ECE/TRANS/WP.29/GRE/2007/25
11 January 2007

REGULATION No. 48
(Installation of lighting and light-signalling devices)

Proposal for draft amendments to Regulation No. 48

Submitted by the expert from Japan

Figure 3 Glare from the following vehicle (the distance between vehicles: 3 m)

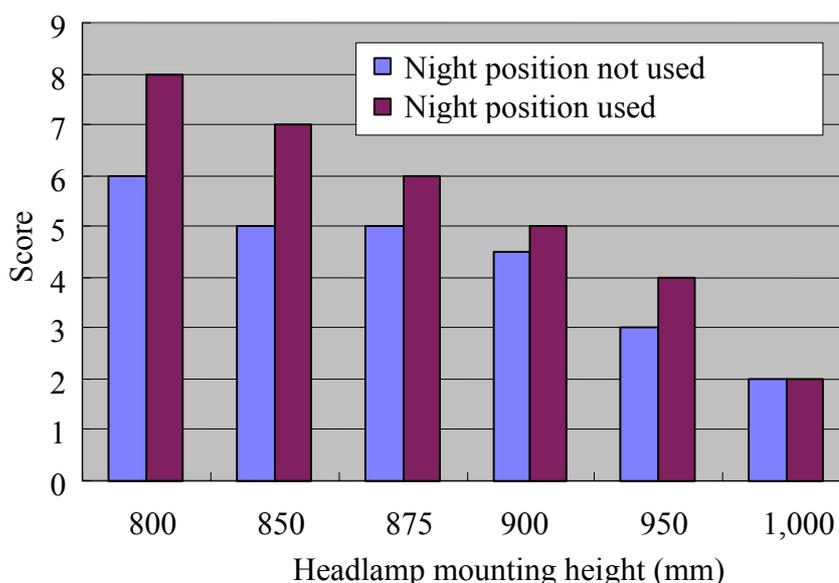
With the mounting heights of 900 mm or more, the glare was outside the allowable limit when the rear-view mirror night position was not used. However, when the night position was used, the glare was within the allowable limits with mounting heights up to and including 900 mm (Figure 3).

By using the rear-view mirror night position, the driver of the leading vehicle can avoid glare problems, provided that the following vehicle headlamp mounting height is 900 mm or less. However, a headlamp mounting height, not greater than 875 mm, is recommended to keep the glare within the allowable limit even when the rear-view mirror night position is not used.

Figure 4 Glare from the following vehicle (the distance between vehicles: 5 m)

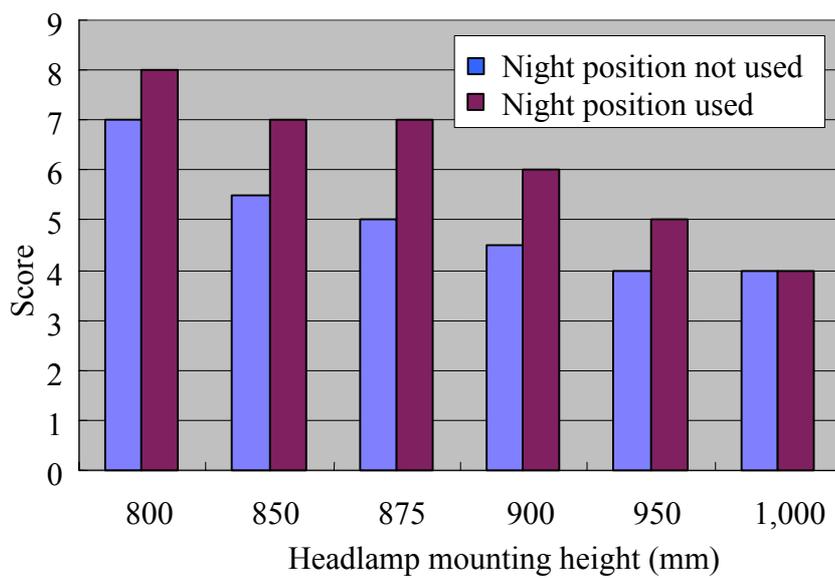
With the mounting heights of 900 mm or more, the glare was outside the allowable limit when the rear-view mirror night position was not used. However, when the night position was used, the glare was within the allowable limits with mounting heights up to and including 950 mm (Figure 4).
